DART AEROSPACE LTD	Work Order:	94464
Description: Gusset	Part Number:	D3016-15
Inspection Dwg: D3016	Rev: A	Page 1 of 1

DESIGN	DRAWN BY	DART AEROSPACE LTD HAWKESBURY, ONTARIO, CANADA	
CP	CP	REV. A	
CHECKED	APPROVED	DRAWING NO.	SHEET 1 OF 3
#	#	D3016	
DATE	TITLE		SCALE
01.05.18	SEAT FRAME ASSEMBLY		NTS
A	01.05.18	NEW ISSUE

DRAWING NO. D3016	TITLE SEAT FRAME ASSEMBLY	REV. A	DART AEROSPACE LTD ENGINEERING ORDER	D.E.O. NO. D3016-A-1	SHEET NO. SHEET 1 OF 1	SCALE NTS
DRAWN <i>1</i>	CHECKED <i>JP</i>	MFG. APPR. <i>RE</i>	APPROVED <i>WJ</i>	DE APPR. <i>WJ</i>		
DATE 10.01.29	DATE 10.01.29	DATE 10.01.29	DATE 10.01.29	DATE 10.01.29	DATE 10.01.29

TO REVISE D3016-11 SADDLE'S HOLE SIZES

D3016-11 SADDLE

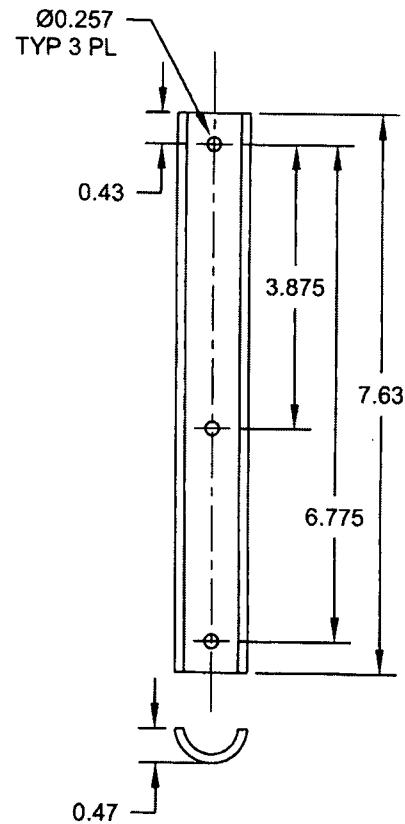
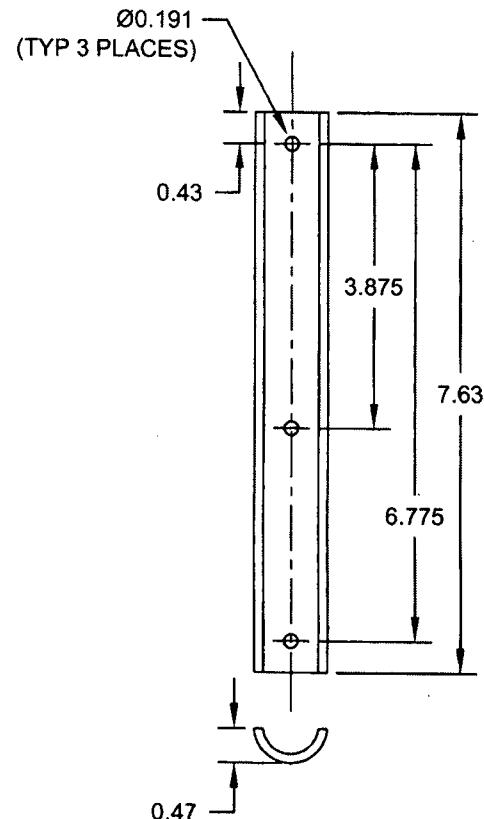
DETAIL D3016-11 SADDLE (SHEET 3): Ø0.257 TYP 3 PL WAS Ø0.191 (TYP 3 PLACES) AS SHOWN:
